Consolidated Draft Briefing Reports

Assessment and opinions on specific
topics related to Aurora Energy's June
2020 Customised Price Path application

Produced for the Commerce Commission

November 2020

Figure 1 - Frankton 33 kV GXP daily peak demand (days of week not aligned)

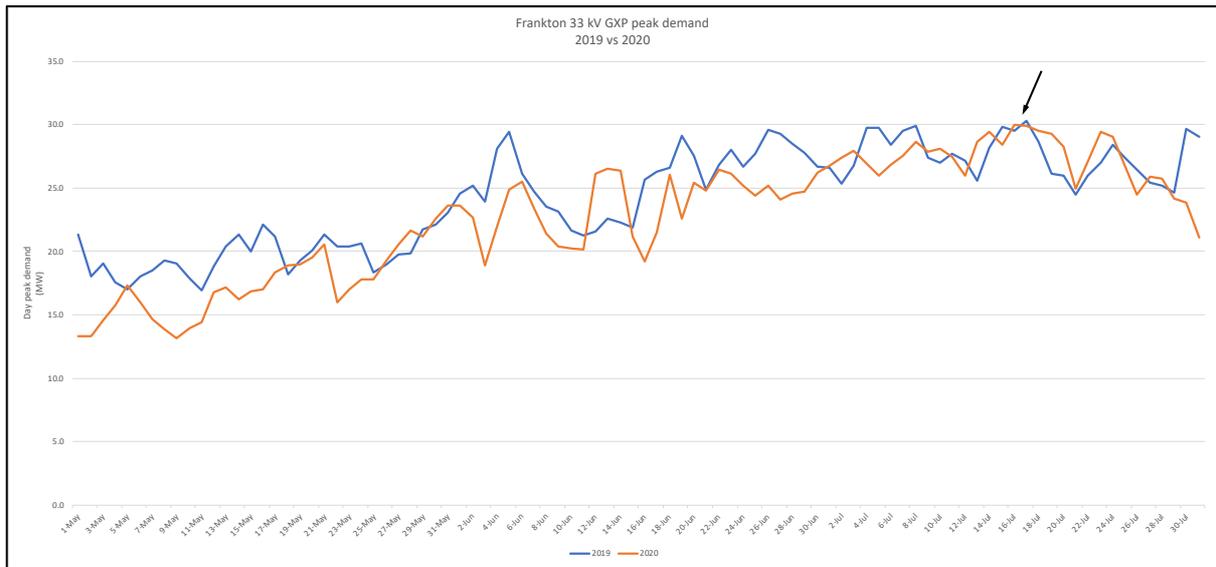
The plots show that peak demands occurred around 16-17 July in both 2019 (30.3 MW) and 2020 (30.0 MW). We do not know the extent to which Aurora was controlling load at these peaks, if it was controlling at all. The plots are also not normalised to account for different weather conditions (colder temperatures generally drive higher peak demands).

Figure 2 - Daily energy exported from Frankton GXP, mid-May to early August (days of week aligned)

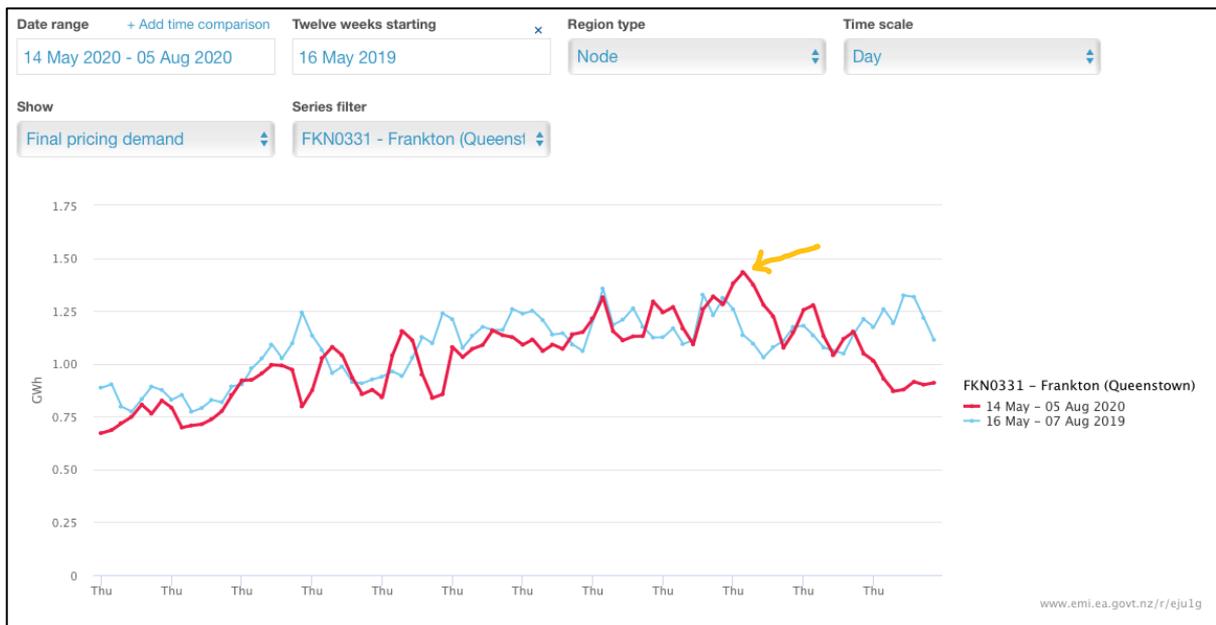
visible in Figure 2 (red line and yellow arrow) and represents a 6% increase over the 2019 peak energy day within the same winter-approximating 12-week window. The 2019 school holiday period occupied the same days as 2020, so the two plots are directly comparable.

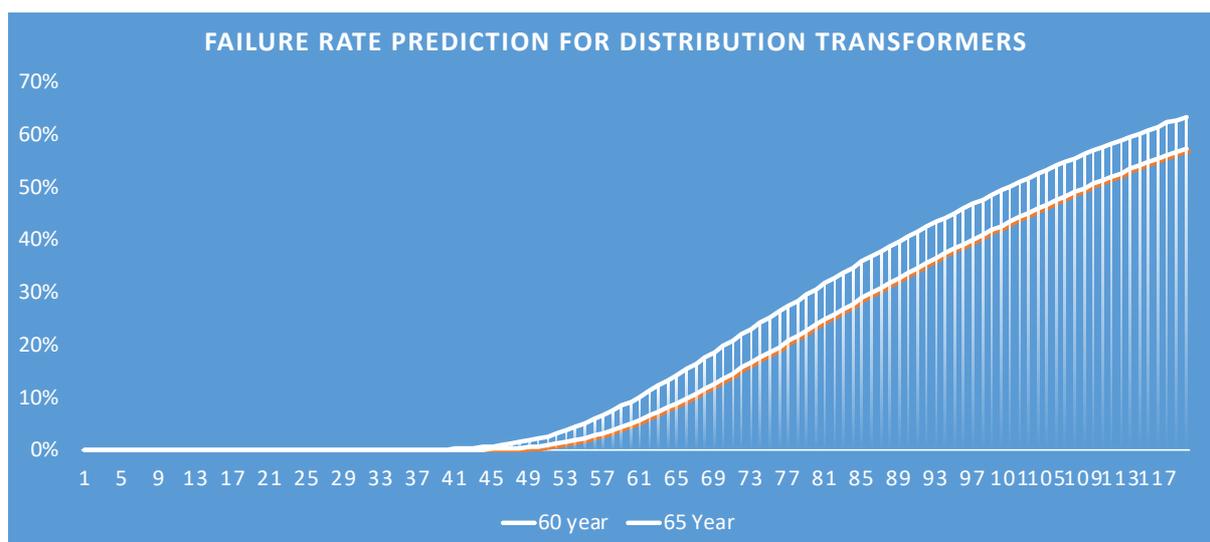
The chart below shows the difference in the assumed failure rate. Given the long-term price impact for consumers from these decisions, the sensitivity to the key input decisions should be tested.

Figure 1: Aurora network maintenance opex over the period RY15–RY19 (constant RY20 dollars)⁸⁰

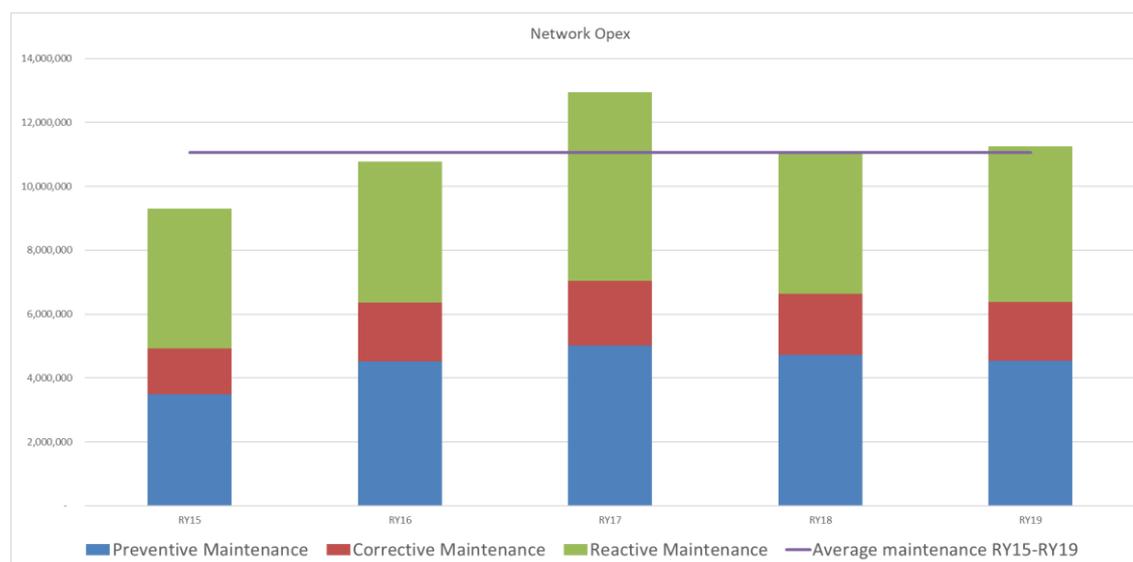
Figure 1 shows the results of our comparison of RY19 network maintenance opex against earlier years. The RY19 opex is very close to the average opex over the five-year period RY15–RY19. This provides us with some comfort that RY19 network maintenance opex does not contain a series of one-off expenditures that are unlikely to be applicable over the CPP and review periods.

Figure 2: Network maintenance opex of distributor cohort over RY13 to RY19 (constant \$RY20)⁸²

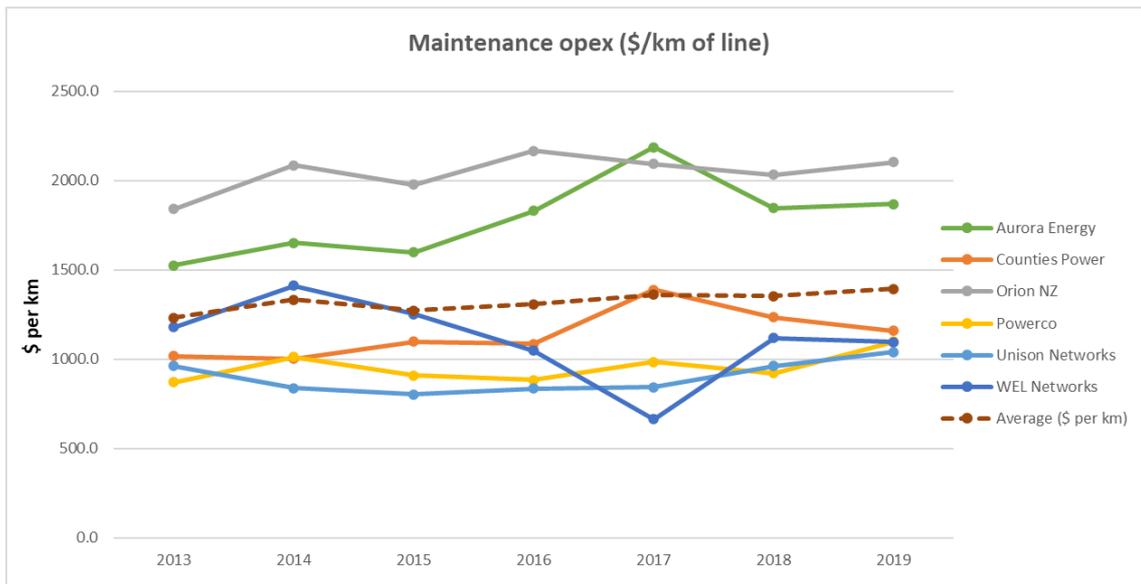
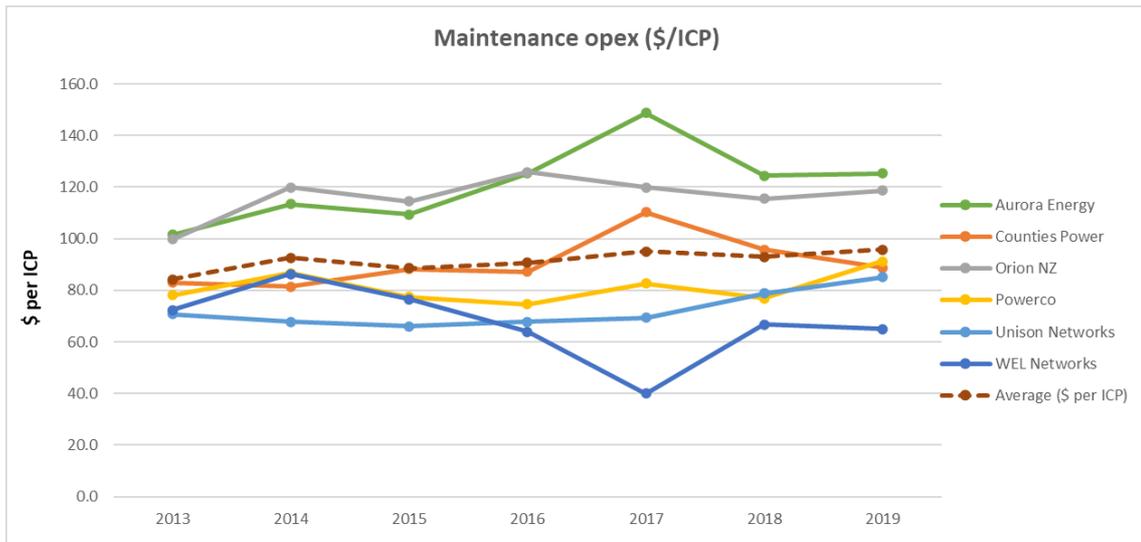
The results of our benchmarking are shown in Figure 2 and Figure 3. The purpose of Figure 3 is to enable a comparison of our benchmarking against the Verifier’s benchmarking, given that our cohort is materially smaller than the Verifier’s. Figure 3 shows our benchmarking results to be consistent with the results of the Verifier’s benchmarking (see Figure 4)—i.e. Aurora’s RY19 maintenance opex is above the average of its peers, but not in a statistically significant manner. However, the standard errors in our benchmarking are much larger than in the Verifier’s benchmarking, because of our small sample size. Therefore, a more pertinent observation is that Aurora’s RY19 maintenance opex is above the average of its peers, but not in an overly material way.

Figure 6: Aurora network maintenance over the period RY15–RY20 (constant RY20 dollars)

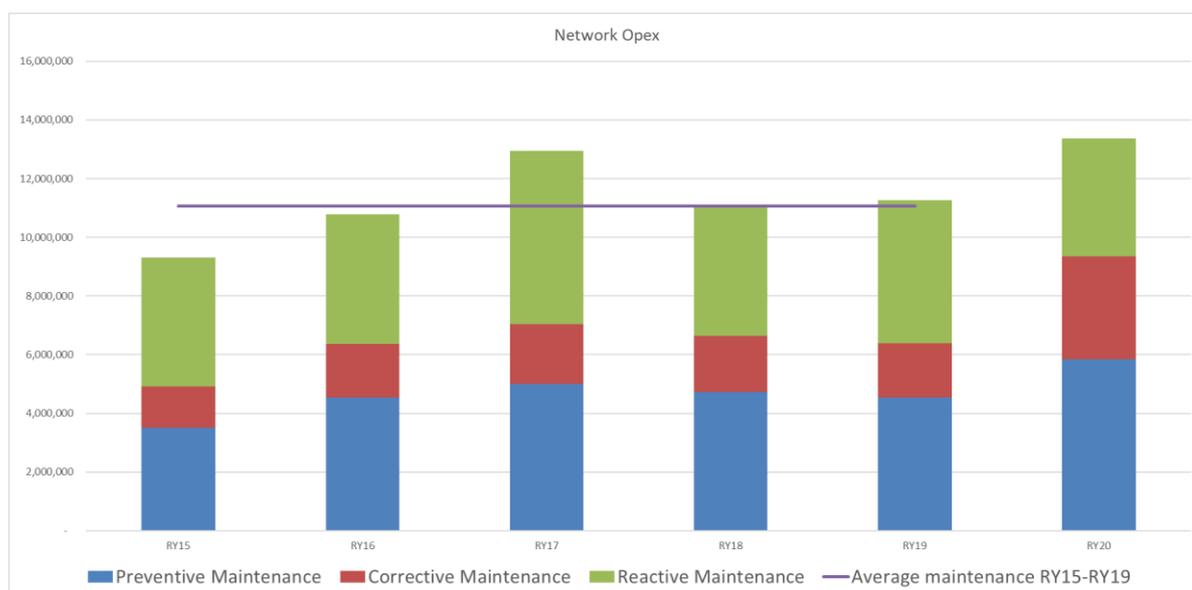
As Figure 6 shows, Aurora’s RY20 maintenance opex is a reasonably material (11.4%) increase over RY19. Aurora notes that some of this can be explained by work that Aurora does not expect to be repeated in RY21 and beyond (e.g. repairs to transformers at the Smith Street substation in Dunedin). However, Aurora believes the RY20 actuals may mean Aurora’s CPP forecast, built on the RY19 base year, is too low.⁸⁸

Figure 1: Contributors to Aurora’s outages 2009–2020

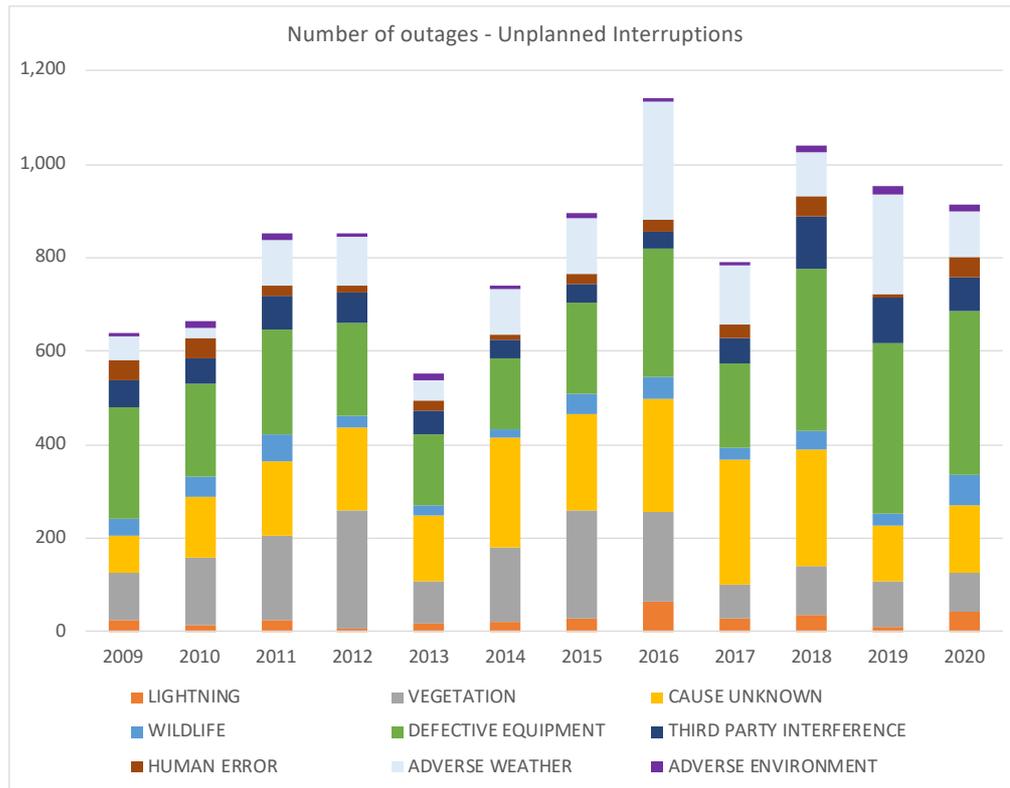
Figures 1 and 2 show Aurora is experiencing an increase in unplanned interruptions across its networks due to deteriorating equipment. Over the past three years, defective equipment has caused 36% of Aurora’s number of unplanned outages (24% of SAIDI and 32% of SAIFI).

Figure 5: Comparison of Aurora’s SONS opex with peer distributors

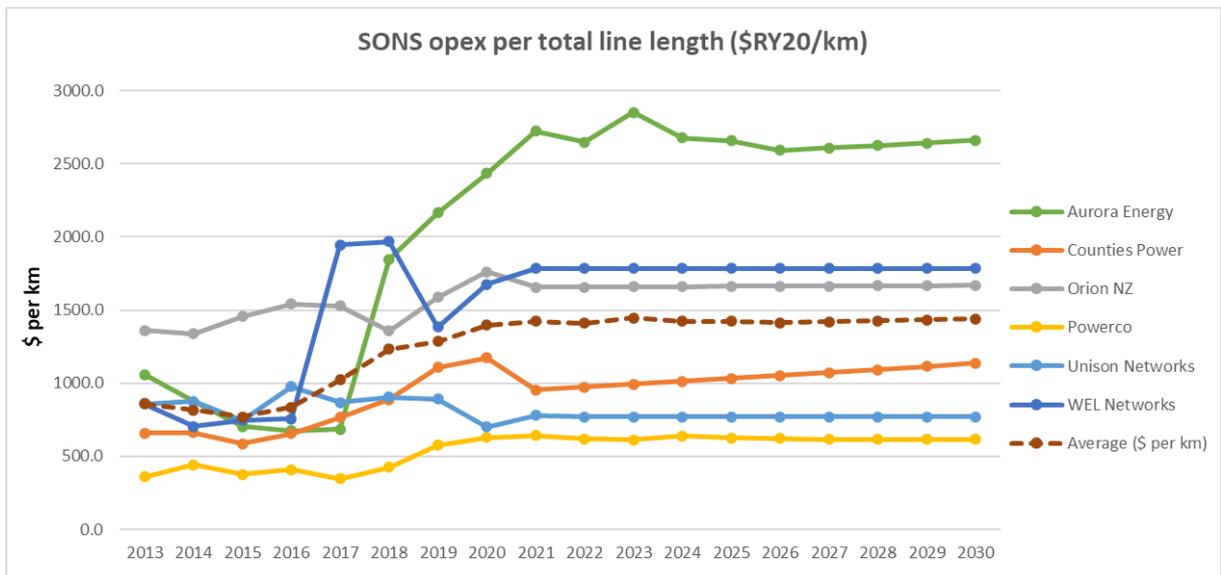
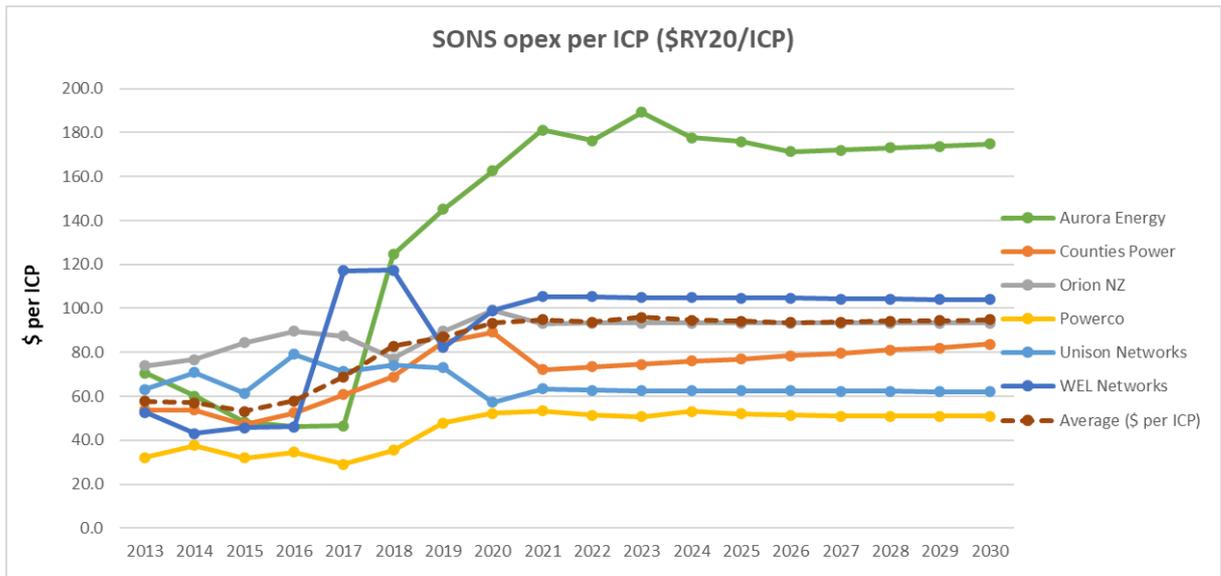
Figures 5–13 show the results of our benchmarking. Figure 5 shows that the significant increase in Aurora’s SONS opex has taken Aurora from being, on average, 93% / 94%²³³ of the cohort average over the period 2013–2017, to being, on average, 182% of the cohort average over the period 2018–2030. If Aurora is excluded from the calculation of the cohort average, while the 93% remains unchanged, the 182% increases to 218%. We note the cohort average includes the increase in Powerco’s opex due to its CPP over the period 1 April 2018 to 31 March 2023. Powerco’s increase is material, as shown in Table 3.

Figure 6: Comparison of Aurora’s Business support opex with peer distributors

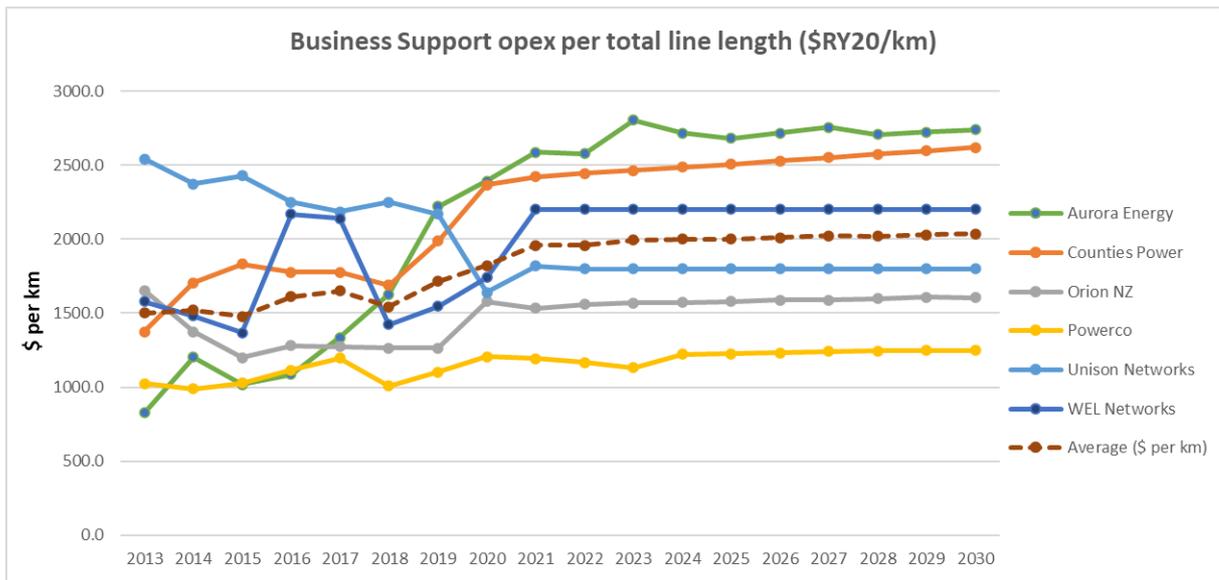
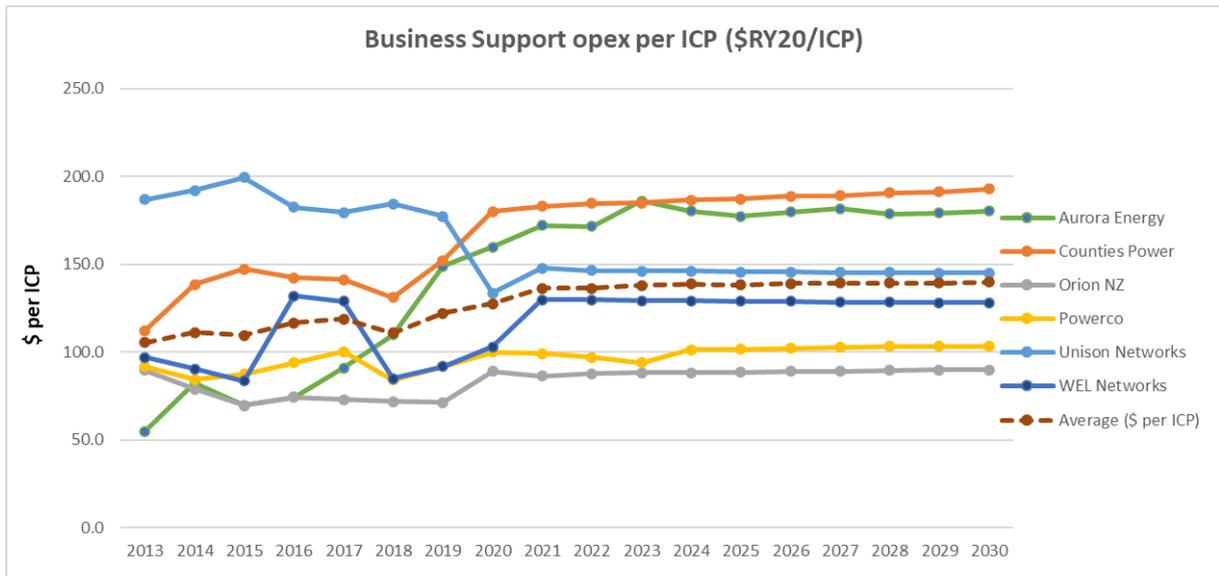
A similar pattern occurs in relation to Aurora’s Business support opex, as shown in Figure 6. Over the period 2013–2017, Aurora is, on average, 66% / 70%²³⁴ of the cohort average, with this increasing to 126% / 132%²³⁵ of the cohort average over the period 2018–2030. Excluding Aurora from the calculation of the cohort average changes the percentages to 62% / 66%²³⁶ and 133% / 141%²³⁷ respectively.

Figure 7: Comparison of Aurora’s Non-network opex with peer distributors

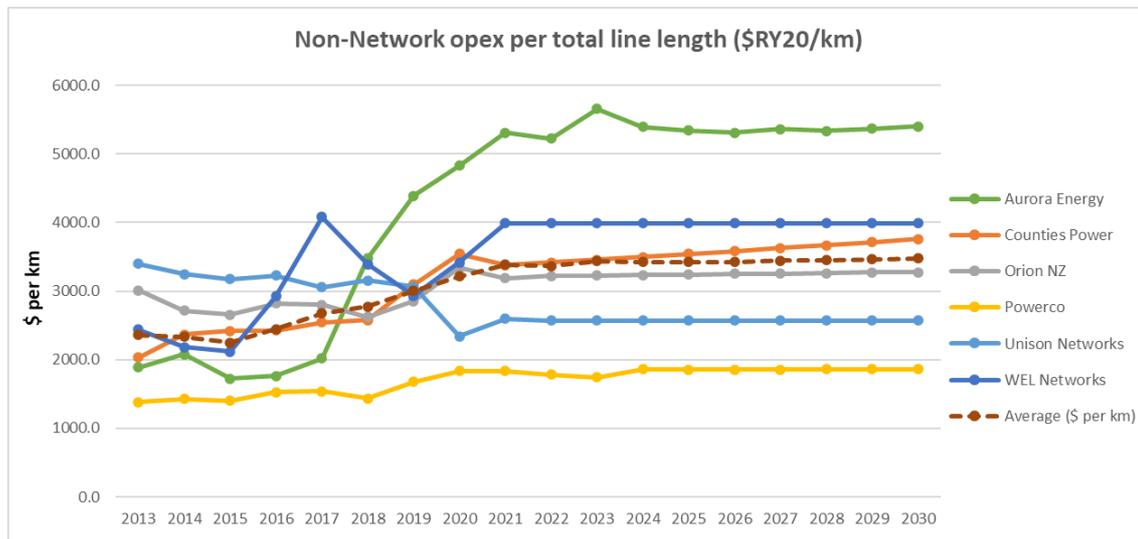
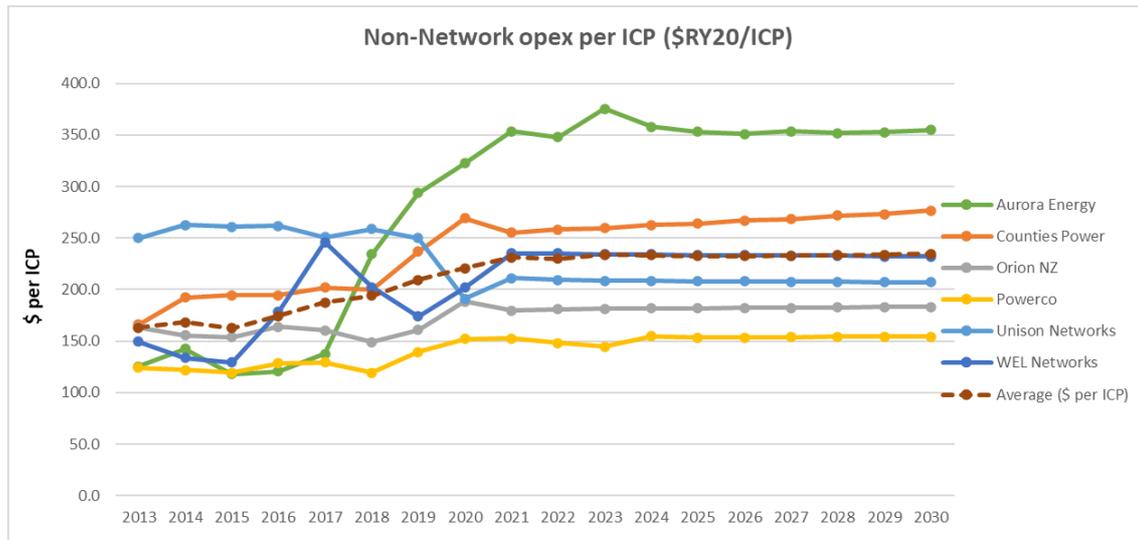
We have included a comparison of Aurora’s Non-network opex against our cohort of distributors, to look at trends in overall opex across the cohort—refer to Figure 7. As can be seen, Aurora’s very high SONS opex dominates overall opex. This is despite Business support opex comprising approximately 60% of Non-network opex, on average.
